Subject: 20160 Mack Avenue: Conditional Rezoning (Map Amendment), Review #2
Parcel ID: 009-01-0001-000
Current Zoning: RO-1, Restricted Office District
Proposed Rezoning: C, Commercial Business District (Conditionally)

Conditional Rezoning Review

MIXED-USE
DEVELOPMENT

20160 Mack Ave, Grosse
Pointe Woods, MI 48236

CONCEPTUAL RENDERING - EXTERIOR

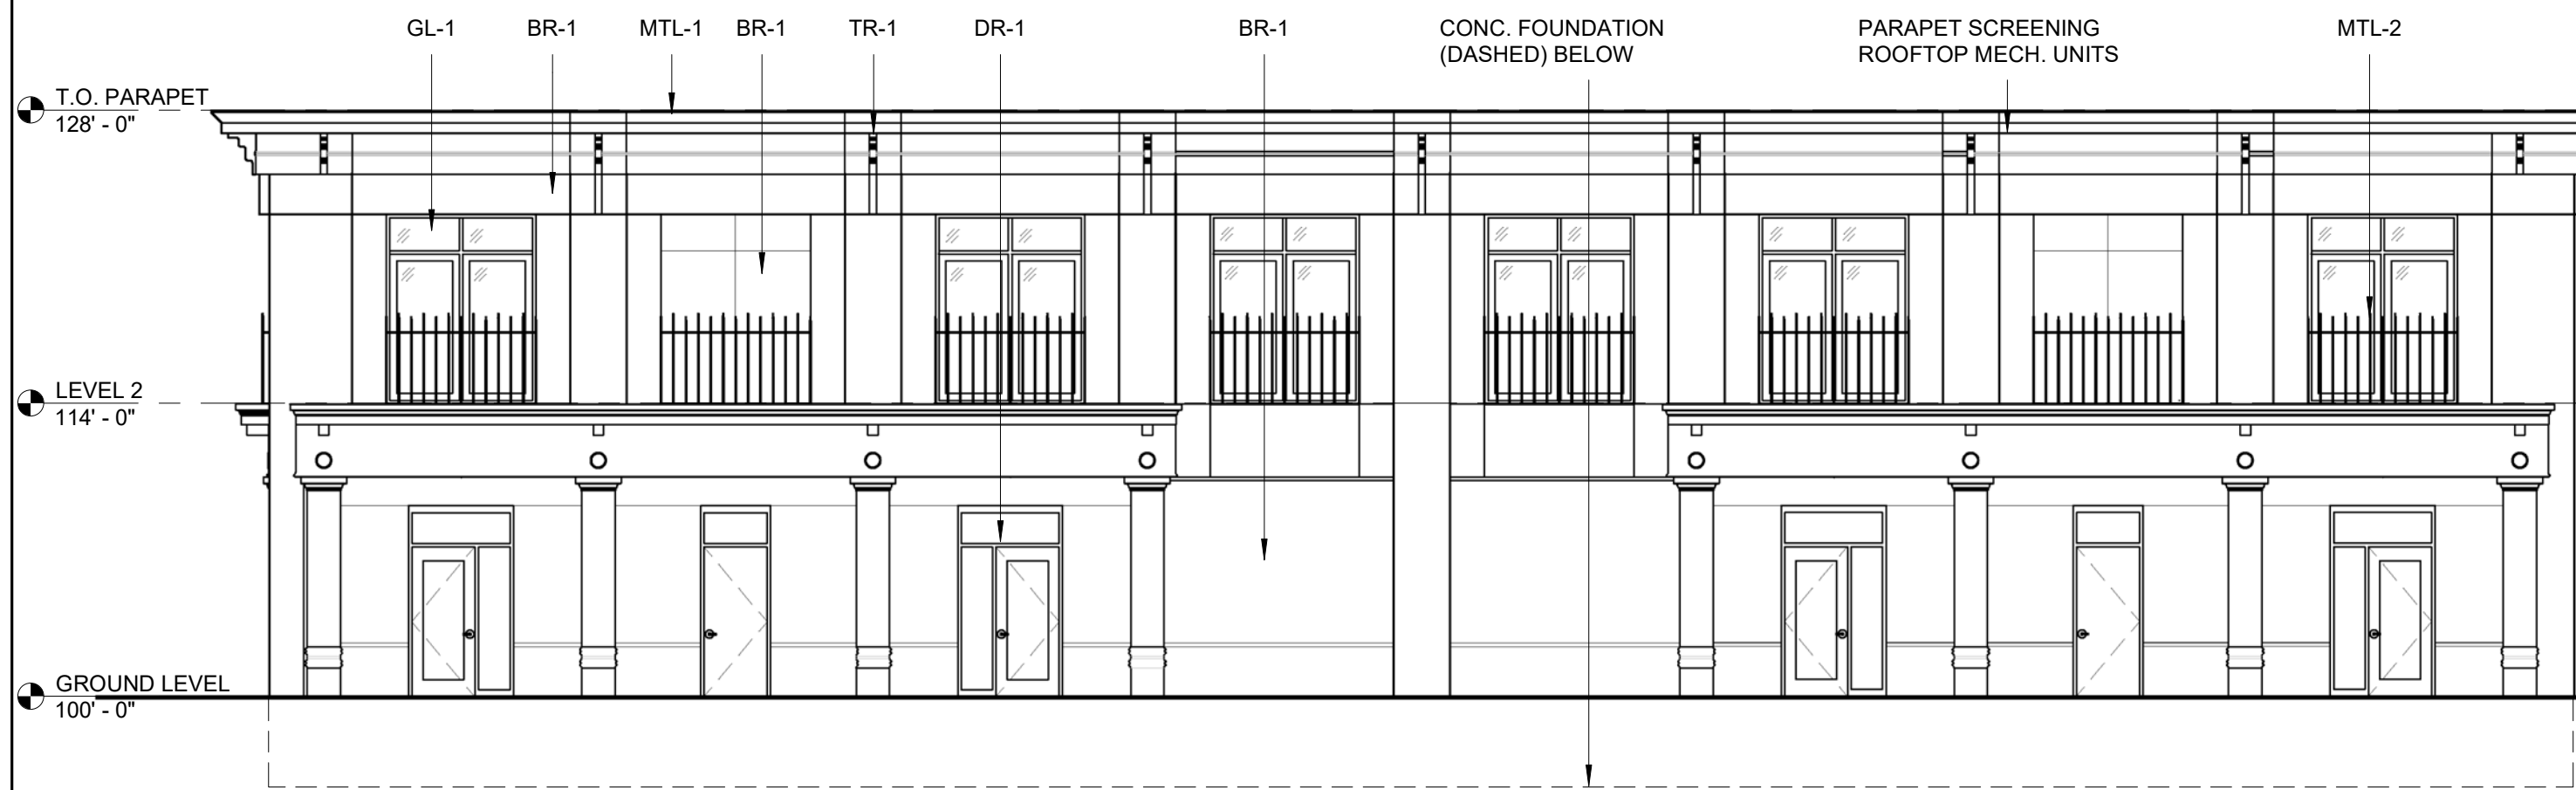
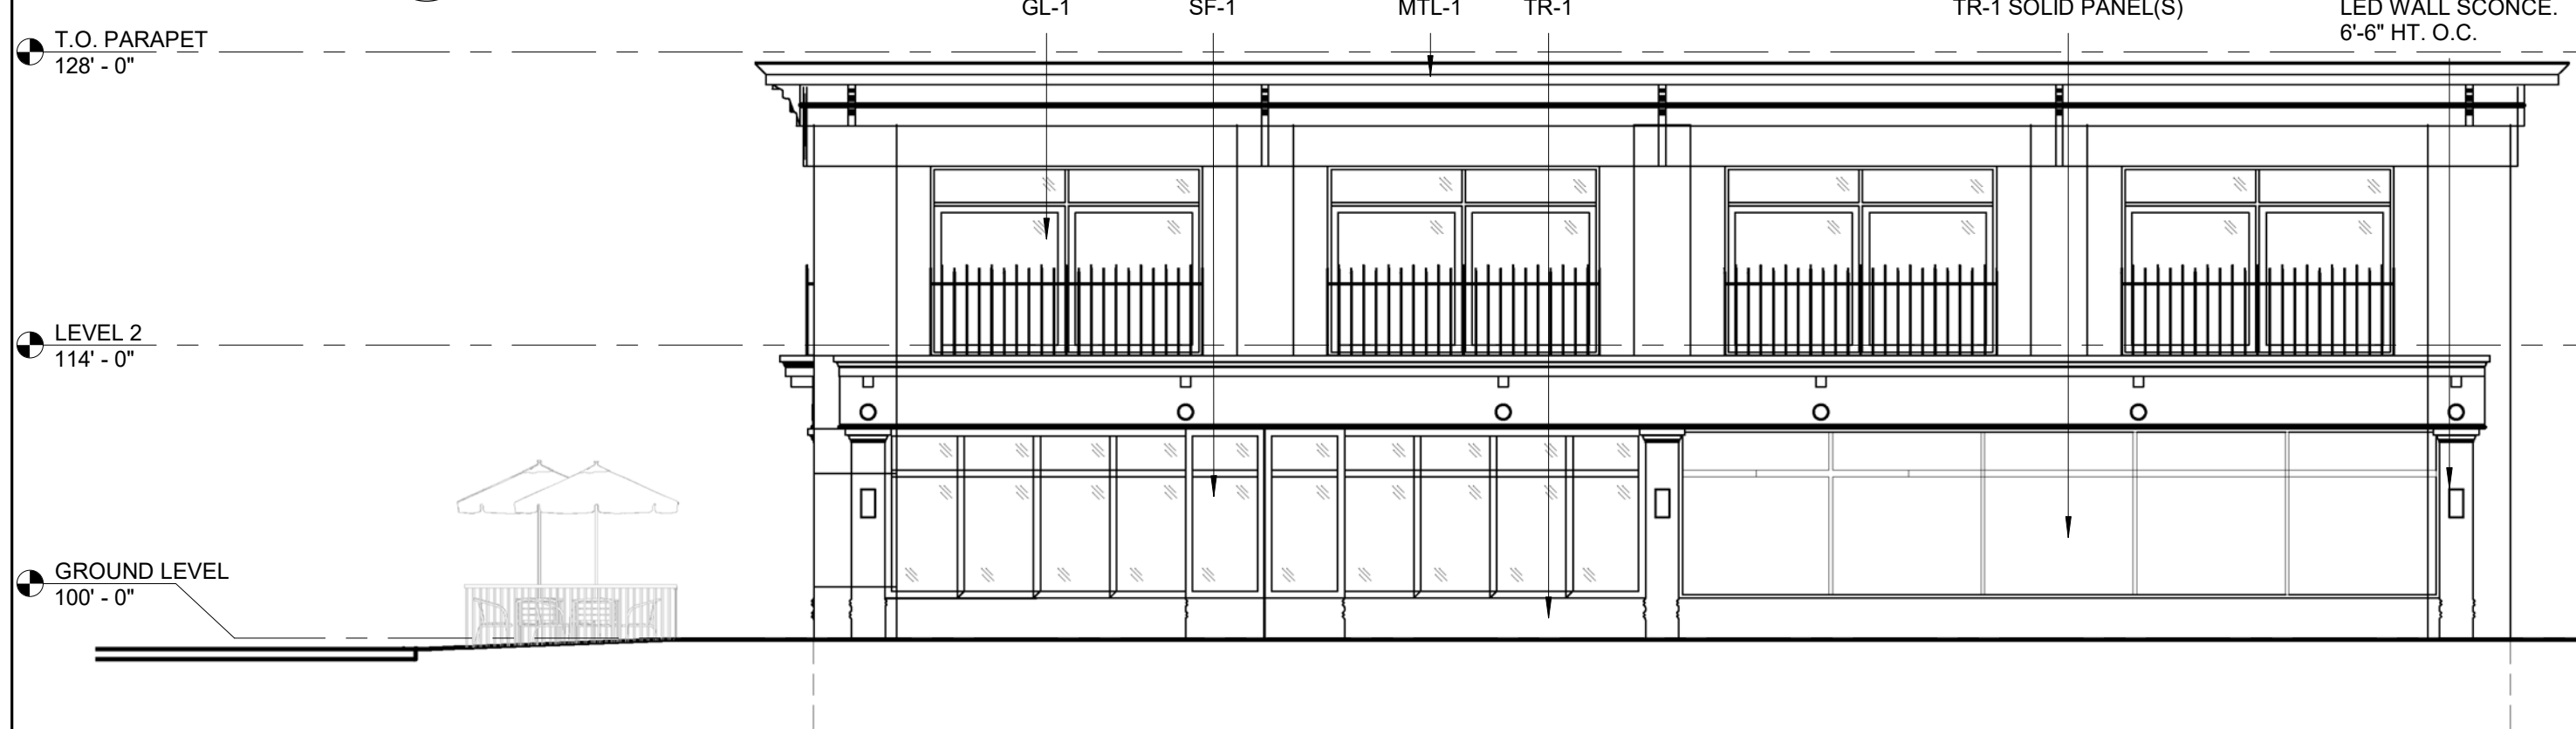
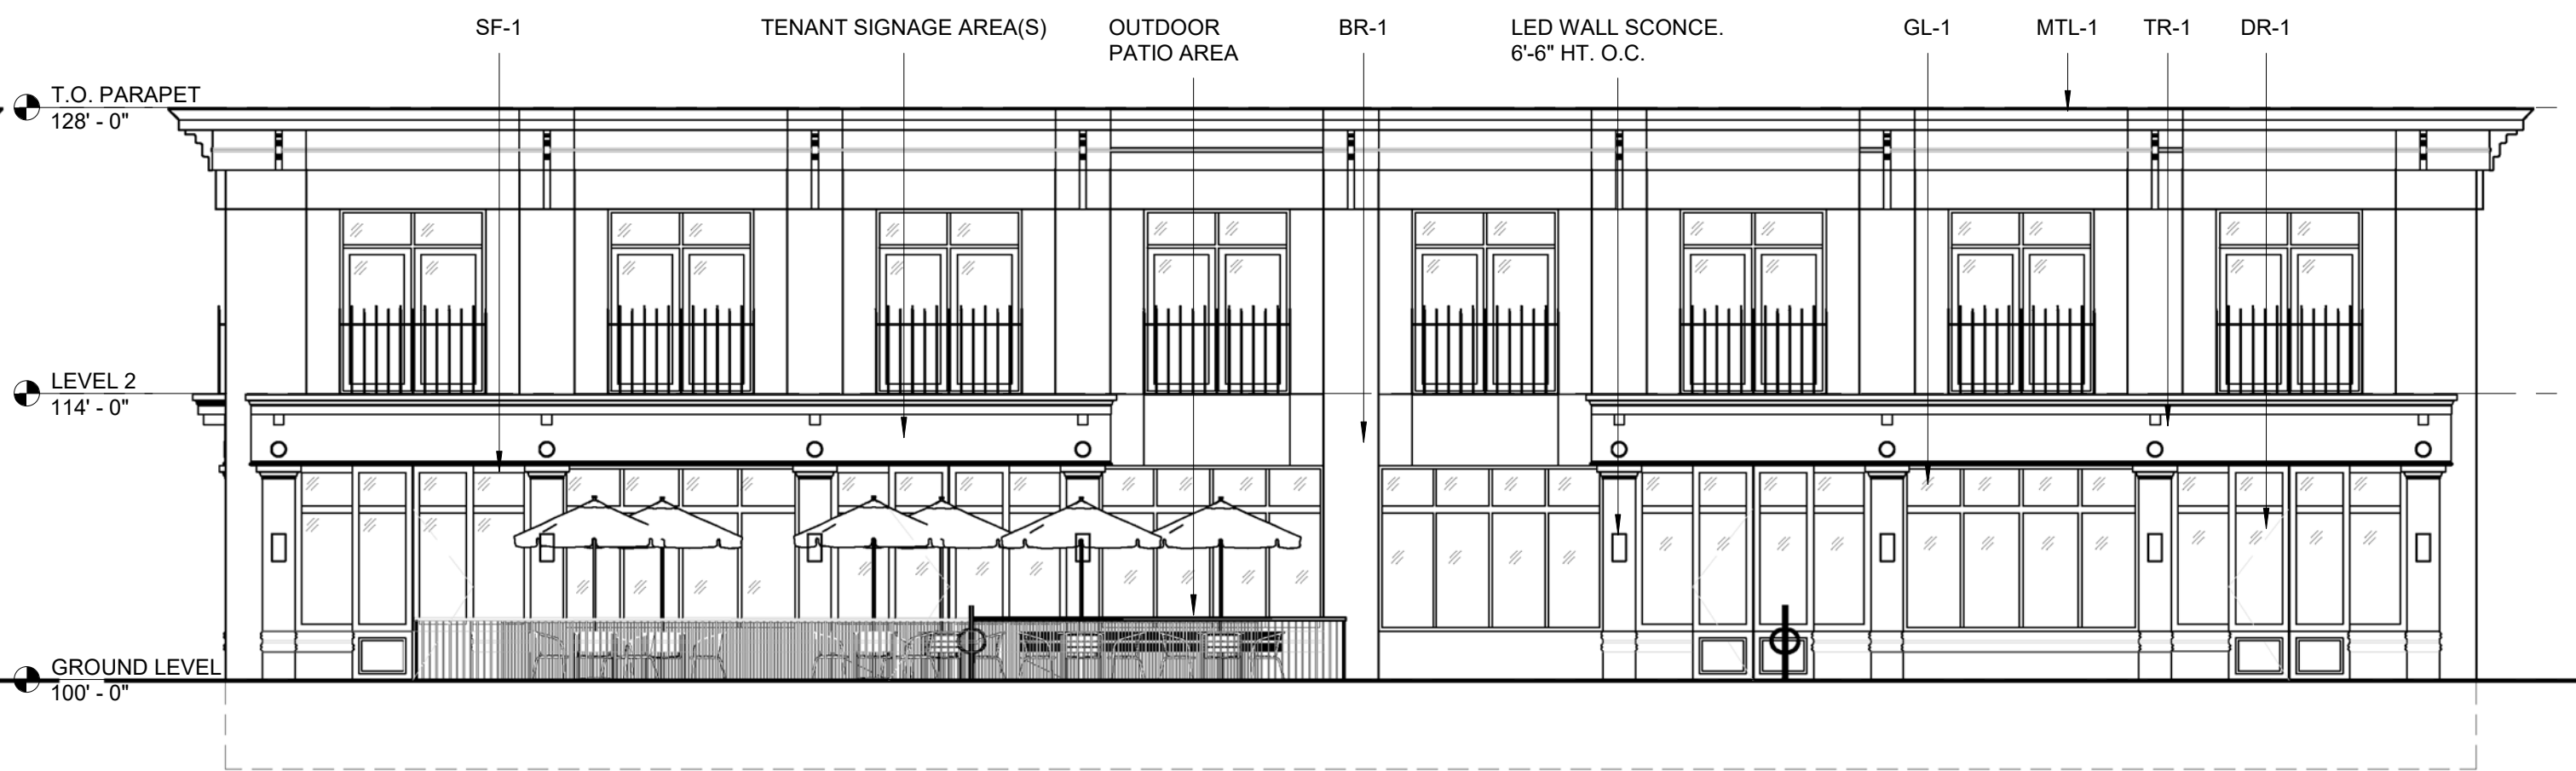
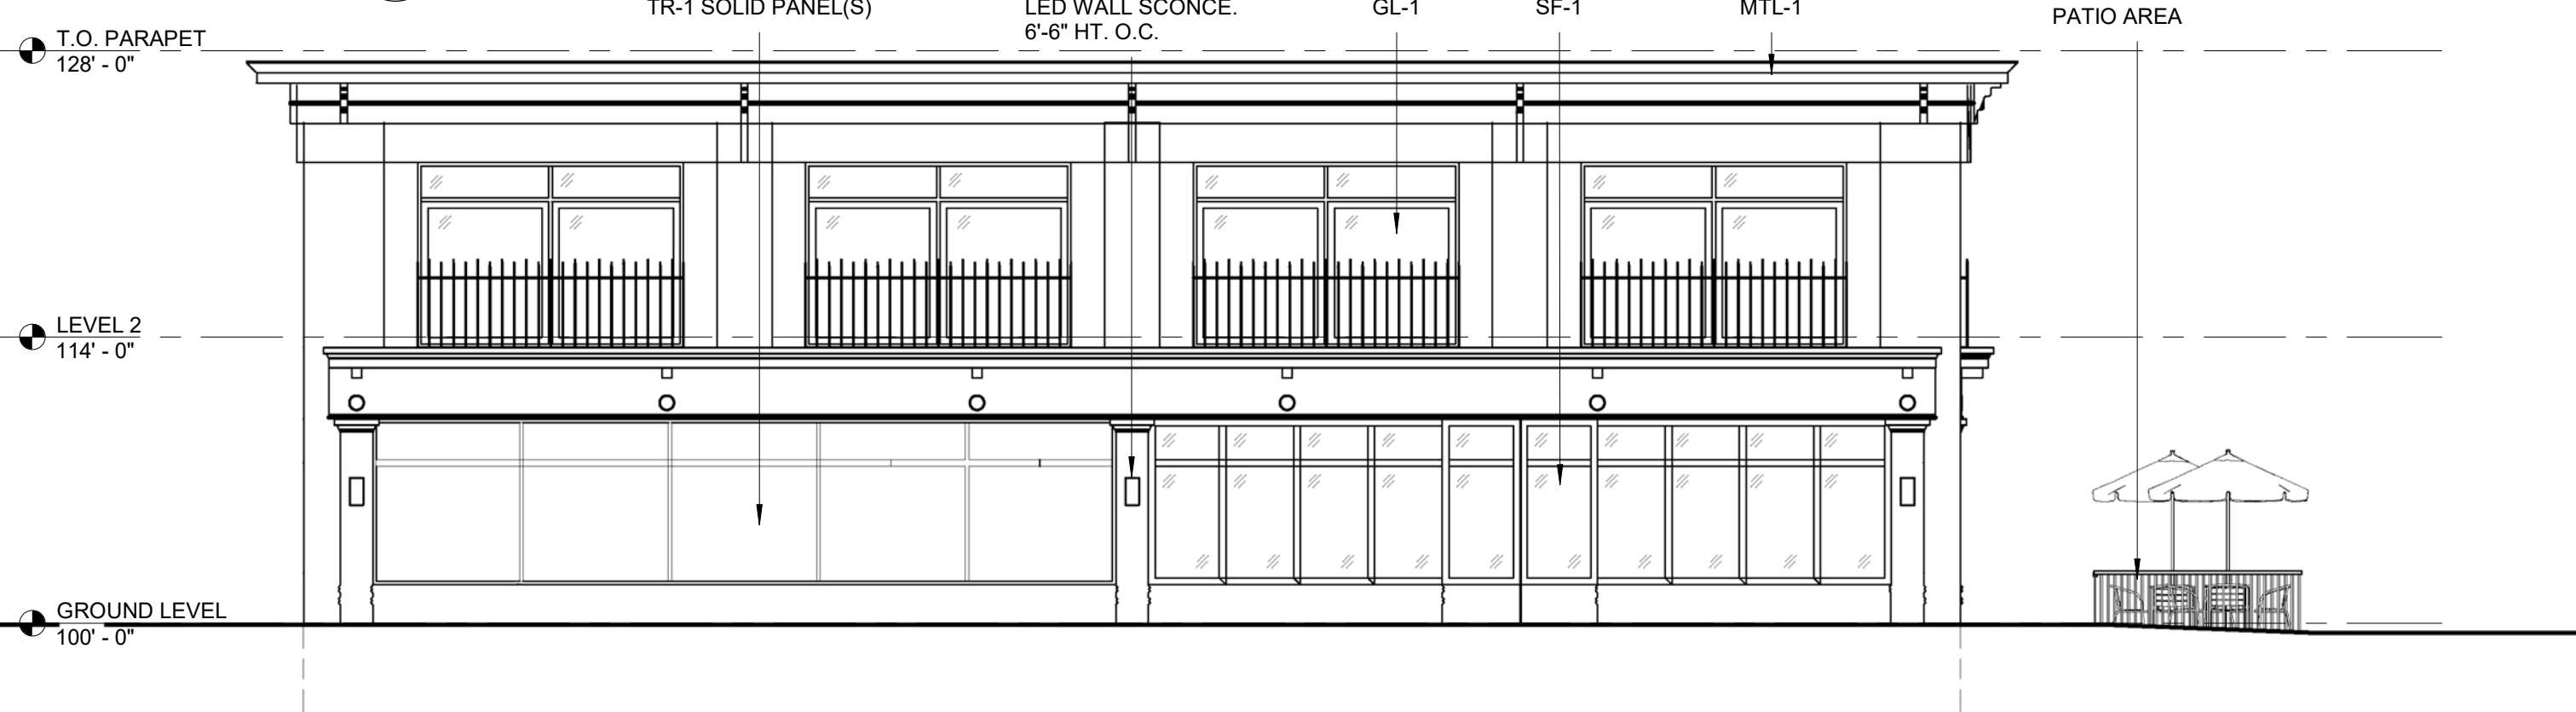
The proposed building will be primarily composed of high-quality brick with dark grey aluminum accents, with additional glass windows on the top and bottom floor facade. The design of the building follows traditional, high quality architectural design which is encouraged by the Zoning Ordinance.

The architectural design features and requirements will be further reviewed during the Site Plan Review process. At this time, the proposed architectural elements are in line with the traditional, timeless design style of the Mack Avenue corridor and of surrounding residential neighborhoods.
